Procedural Review Voting Sheet 2013 Cycle 6

Document 5637	Document Title Revision to SEMI G95-0613, Mechanical Interface Specification for 450mm Load Port for Tape Frame Cassettes in the Backend Process
-------------------------	--

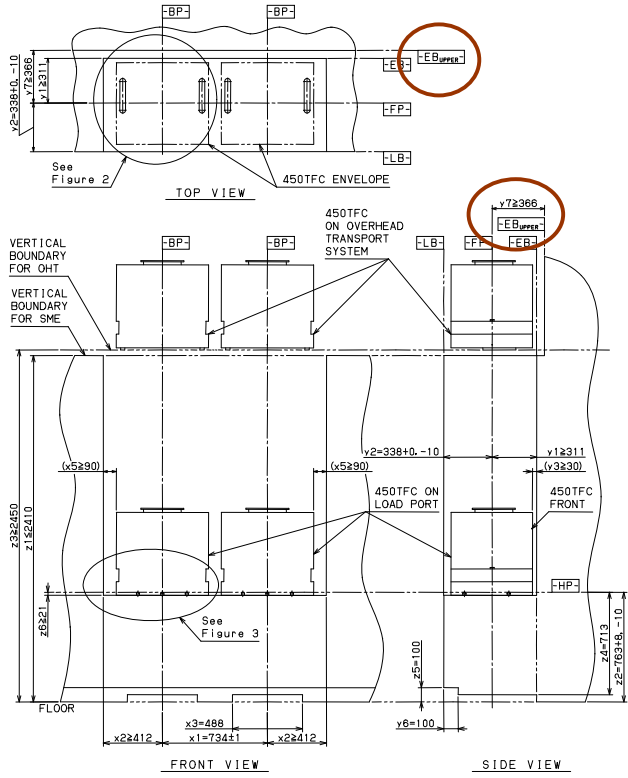
Comment	Referenced Section	Figure 1
	From	Stefan Radloff, Intel Corporation
	Comment	Figure 1 should also be updated so show EBupper (similar to figure 5 in SEMI E154)
	Discussion	Missing indicator parts in "Figure 1" The addition of these circle indicator parts to "Figure 1" (see Case 2: Voted in this section below) were discussed carefully at the Task Force meeting and were acknowledged at the committee meeting. This document was submitted for the ballot. The circle indicators remained in the documents until just before it was submitted to SEMI. However, "Figure 1" is now missing the circle indicators from the balloted document due to a clerical error of SEMI staff. These circle indicators are mentioned in "Table 1" and even though "Figure 1" does make sense without showing these indicators, it is better if they are added back into "Figure 1". This should be an editorial change.
Action proposed	The committee agreed to do one of the following actions.

2	FROM:	
	TO:	
	Justification (If necessary)	
Motion by/2nd	Sumio Masuchi (Disco) / Yutaka Koma (Consultant)	
Vote	9-0 Motion passed	
A&R		Not approved
		Reason:
